**Sizewell C: Review of the
Planning Inspector's Questions on Air Quality**

26 May 2021

Client: Together Against Sizewell C

Reference: S1018

Figure 1: Wind Roses for Wattisham (Observations) and Sizewell (NWP) for 2016

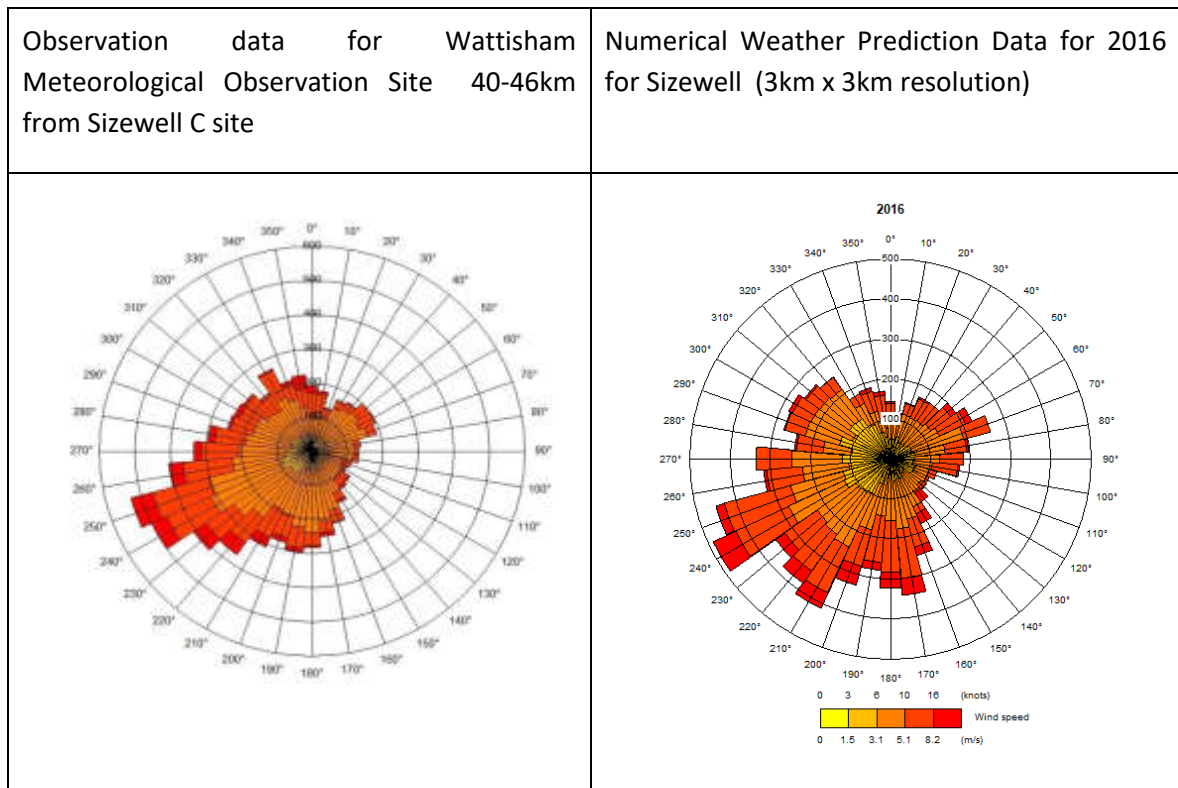
- 3.32 No sensitivity tests were undertaken using different meteorological data. The data used comes from the Wattisham observation site, which is 40km or 46km from the Sizewell C site (both distances are used in the documentation). The figure below shows a comparison for 2016 between the Wattisham and numerical prediction data (NWP) for the 3kmx 3km grid covering the main site. The comparison is for 2016 because this is the year when, in general, the Applicant states the worst-case predictions occurred out of the 5 meteorological years used in the assessment (2014-2018).
- 3.33 The wind roses show the number hours the wind comes from different directions by wind speed. There are some clear differences which would have changed the concentrations predicted by the dispersion model. In particular, there due to the more frequent winds from approximately the north east to east (30° to 100°).
